**Code-Making Panel 15**  
**Public Input Report (A19)**

## Public Input No. 3453-NFPA 70-2017 [ Global Input ]

**Figure Informational Note Figure 517.31(a) Hospital — Minimum Requirement (greater than 150 kVA) for Transfer Switch Arrangement.**

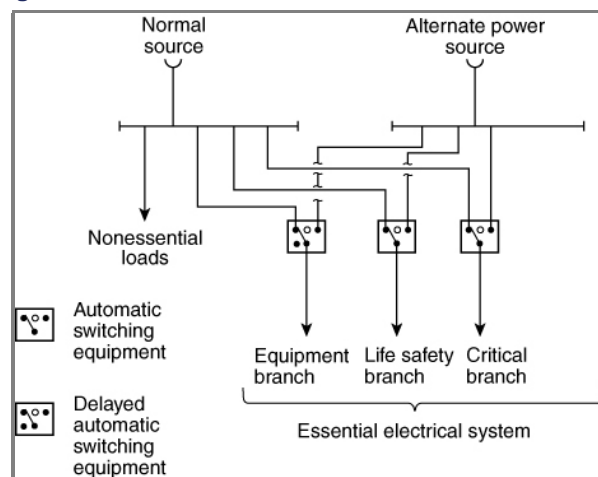
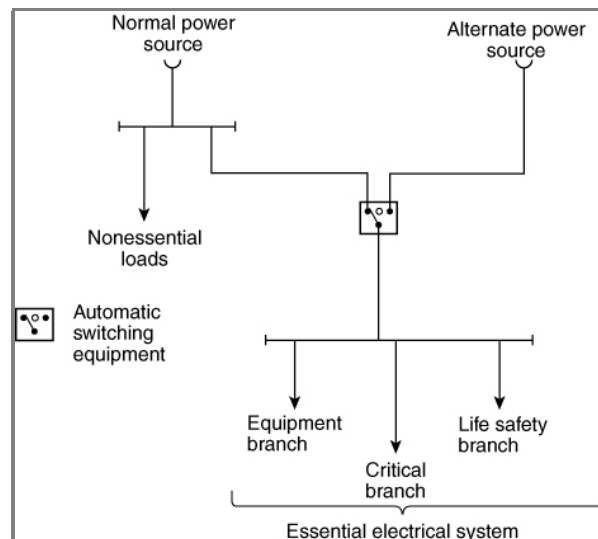
Informational Note No. 2: See Informational Note Figure 517.31(a).

Informational Note No. 3:-- In consideration of future growth, multiple branches should be considered. See Informational Note Figure 517.31(b).

**Figure Informational Note Figure 517.31(a) Hospital — Minimum Requirement (greater than 150 kVA) for Transfer Switch Arrangement.**

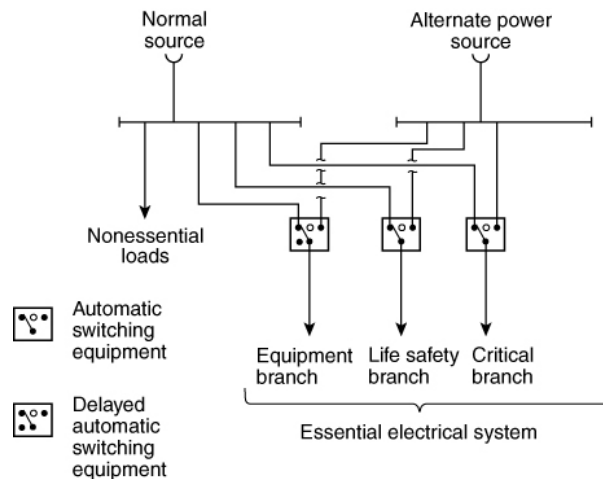
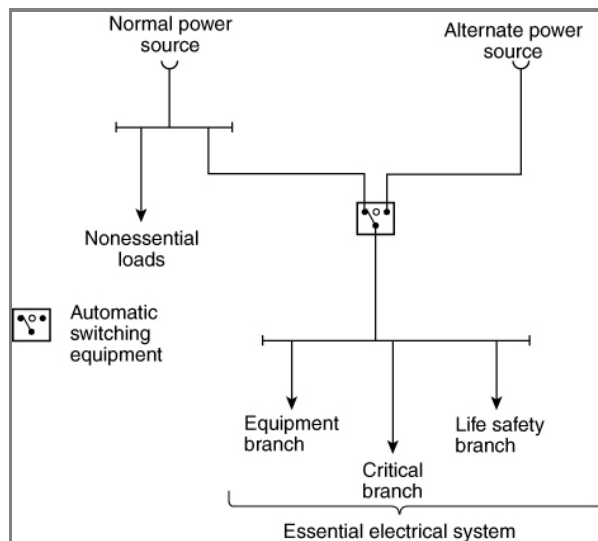
NEC 700.10(B)(5) requires all "Emergency", "Legally Required Standby", and "Optional Standby" loads be segregated from each other. The people in facilities covered by Articles 700 are typically able to exit the building under their own power. Yet in a Health Care facility, where it is common that we have people potentially unable to exit the building under their own power, we are relaxing the requirements related to the segregation of loads when the load on the Essential Electrical System is less than 150 kVA. This change would bring the requirements in article 517 in harmony with the same requirements of NEC 700.10(B)(5) for all conditions.

**Figure Informational Note Figure 517.31(a) Hospital Type 1 Essential Electrical System — Minimum Requirement (greater than 150 kVA) for Transfer Switch Arrangement.**

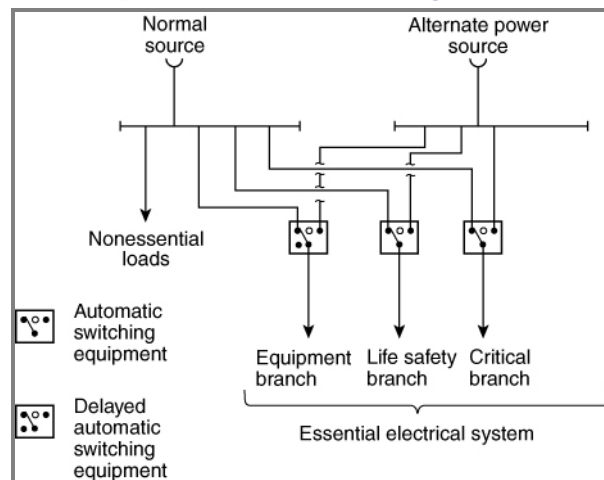
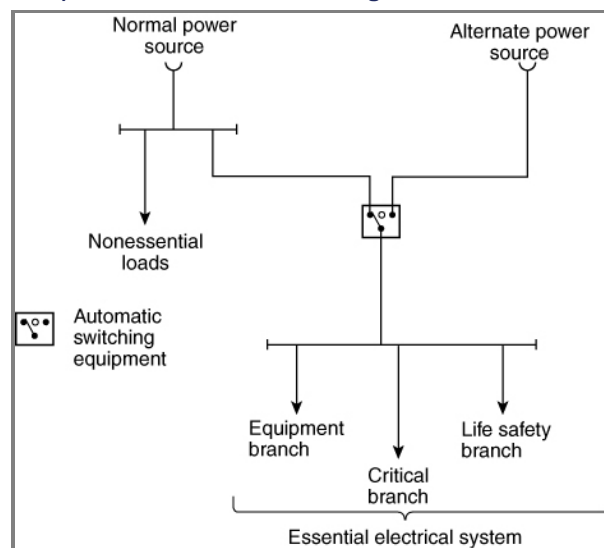
As the Chair of NFPA 99 Electrical Systems Committee (HEA-ELS), I am submitting this proposal to improve the correlation between NFPA 99 and NFPA 70. The substantiation of this proposal is as follows: Remove the reference to the specific facility type. NFPA 99 already defines what facilities need to be provided with a Type 1 EES and that is based on the risk present in the facility.

**Figure Informational Note Figure 517.42(a) Nursing Home and Limited Health Care Facilities — Minimum Requirement**

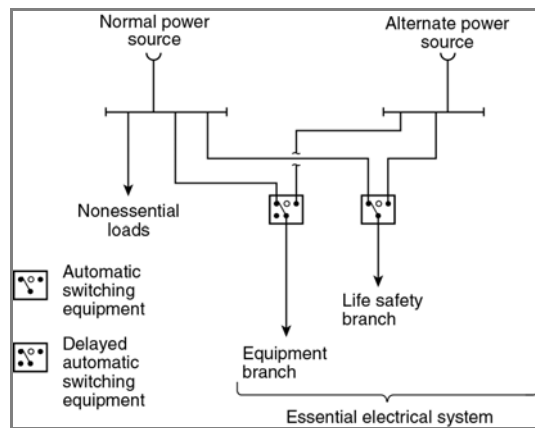
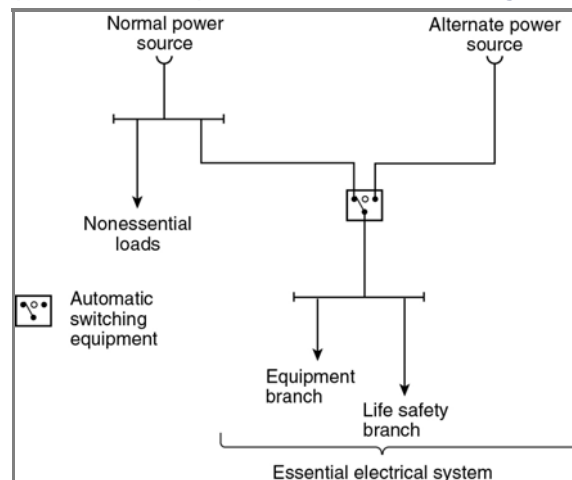
NEC 700.10(B)(5) requires all "Emergency", "Legally Required Standby", and "Optional Standby" loads be segregated
